P802.1Qdq Text Improvement

17 January 2023

Overview

Figure X-4—Traffic pattern in application's point of view

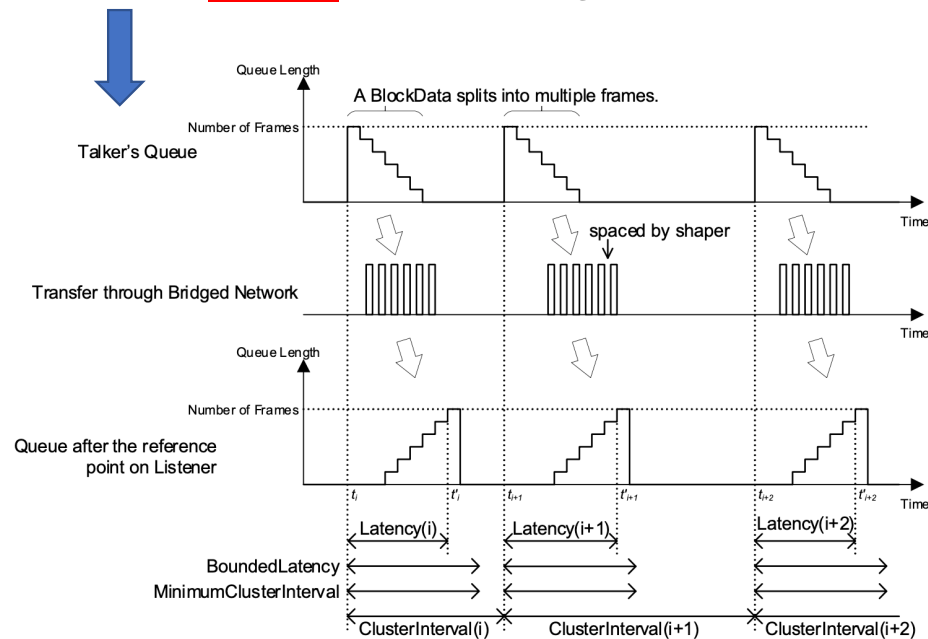
- Clause X.2 Page 24 Line 9
- Comment
 - Figure X-6 page 27 contradicts equation (X-2)
- SuggestedRemedy
 - include portTcMaxLatency in (X-2)
- Commenter submitted the following supporting figures:
 - <https://www.ieee802.org/1/files/public/docs2022/dq-Turner-D0-2-comment-4-1122-v01.pdf>

This is **INPUT** of Talker's Queue

- In Figure X-4, change “Talker’s Queue” to “Input of Talker’s queue”
- In Figure X-5 and X-6, add illustrations of “Input of Talker’s queue”

Figure X-6—The worst-case budget calculation

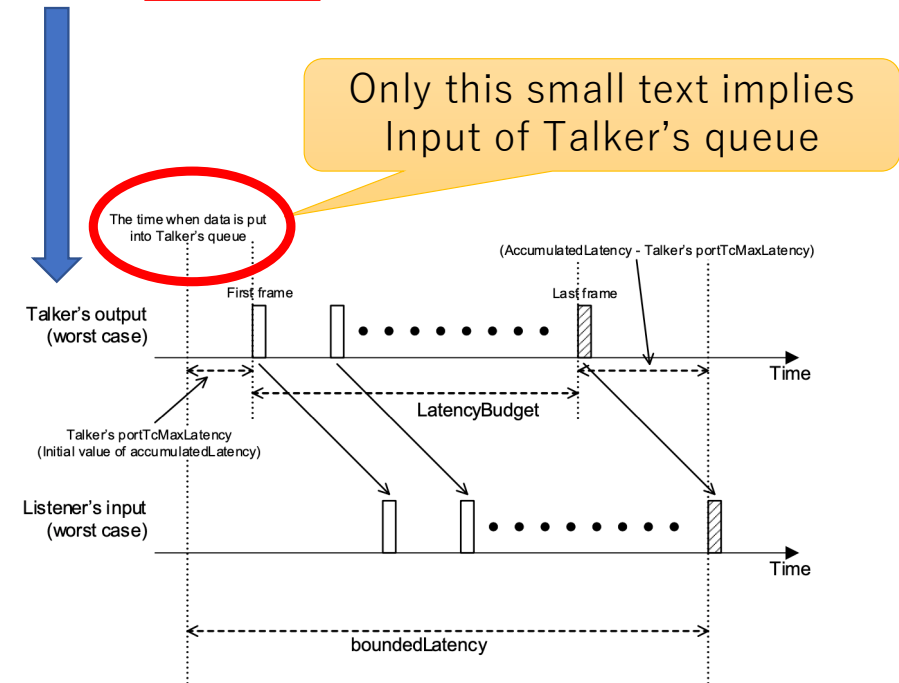
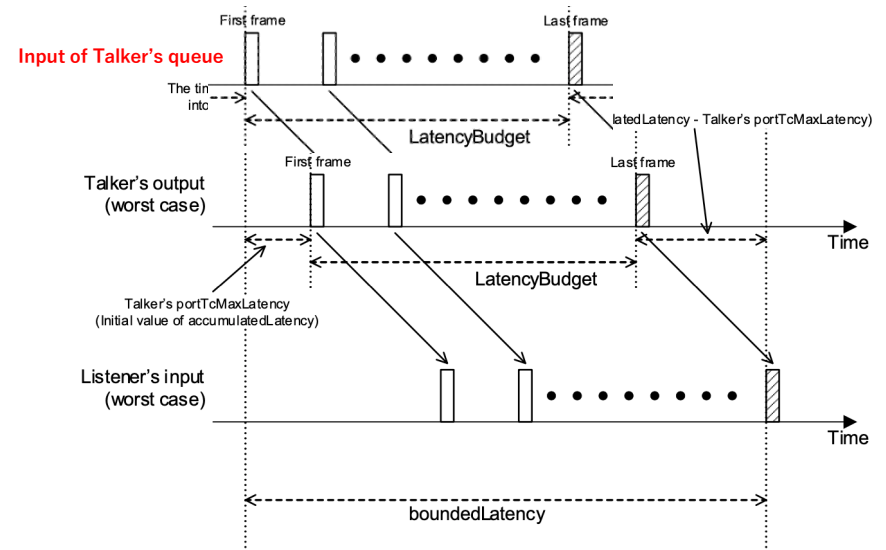
This is **OUTPUT** of Talker's Queue
